**MONTGOMERY COUNTY PLANNING BOARD**  
THE MARYLAND-NATIONAL CAPITAL PARK AND PLANNING COMMISSION

MCPB No. 18-025  
Sketch Plan No. 320180090  
850 Sligo Avenue  
Date of Hearing: April 5, 2018

**CORRECTED RESOLUTION**

**DATE:** 09-Oct-18  
**TO:** Andrew Bradshaw - abradshaw@jba-inc.net  
Johnson Bernat Associates  
**FROM:** Marie LaBaw  
**RE:** 850 Sligo Ave  
120190090 820190050

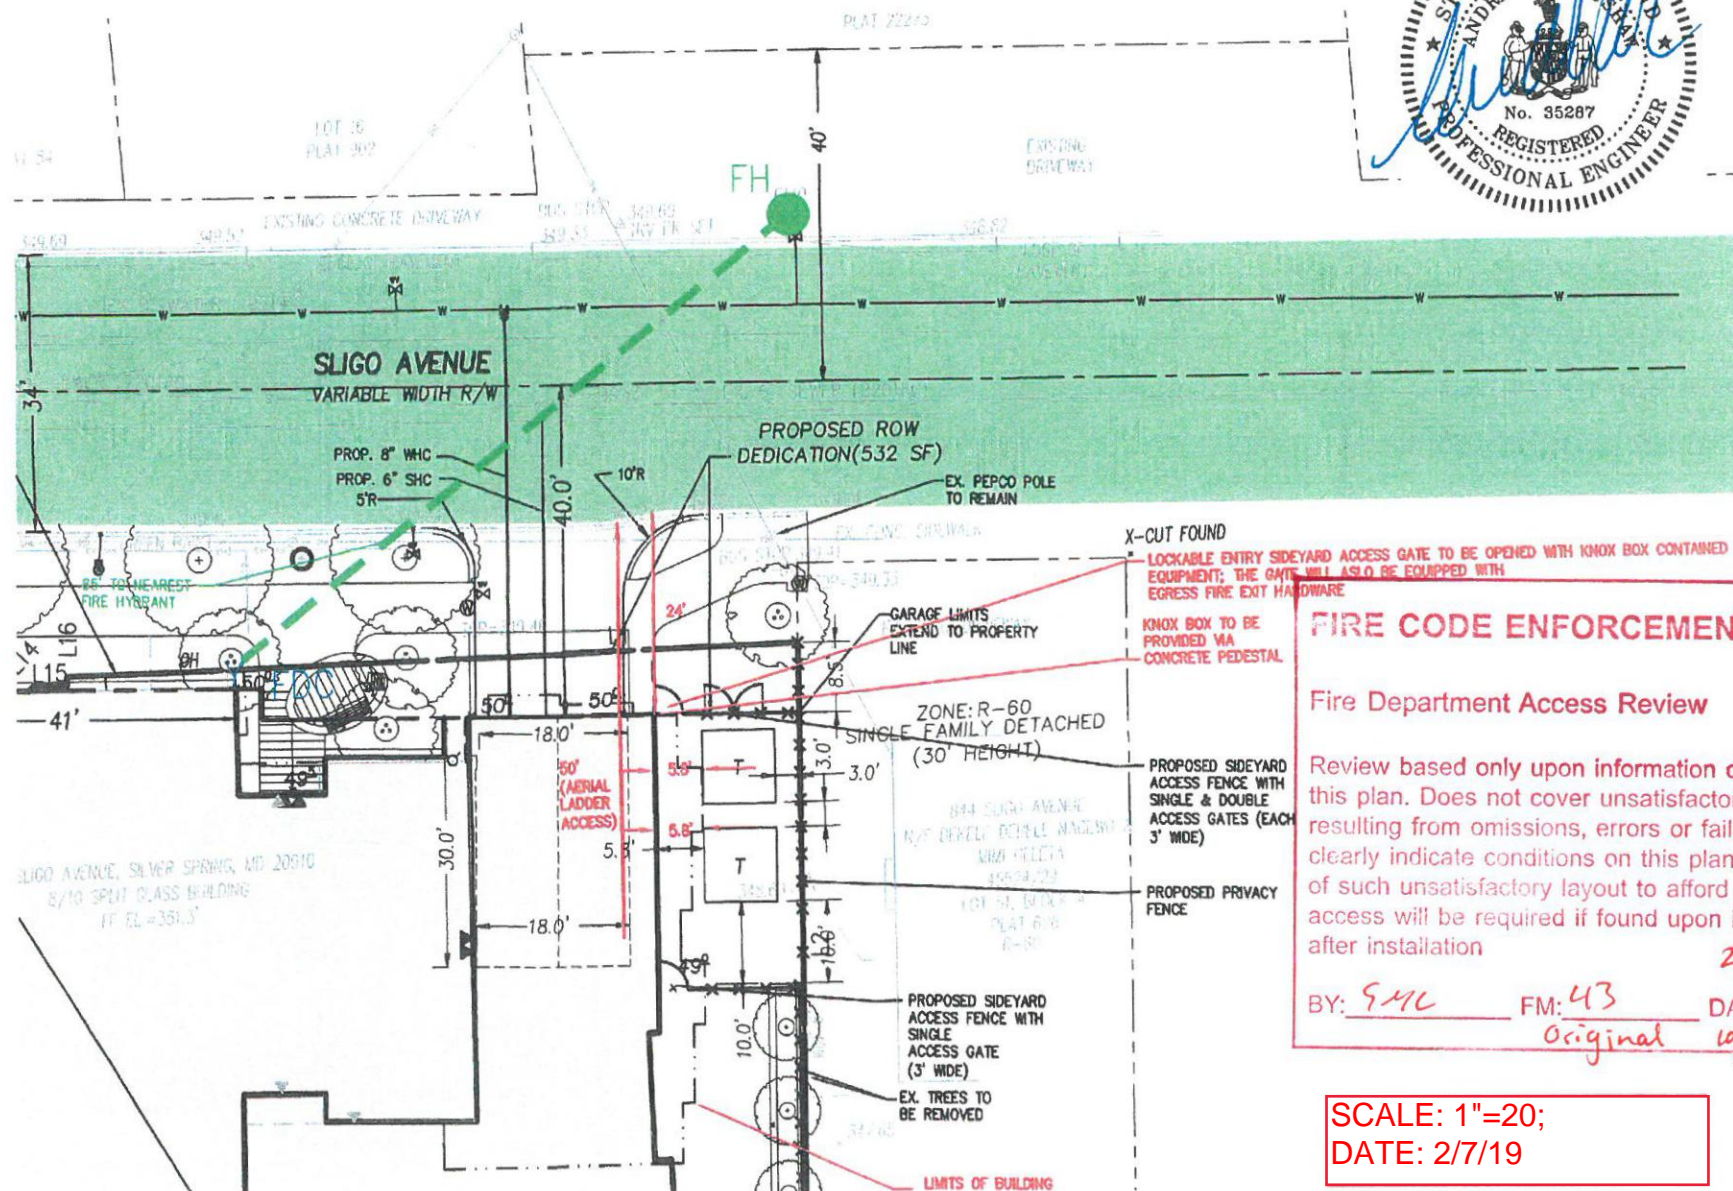
**PLAN APPROVED**

**\*\*\* 2/7/2019 Amendment: added transformers at NE corner of building \*\*\***
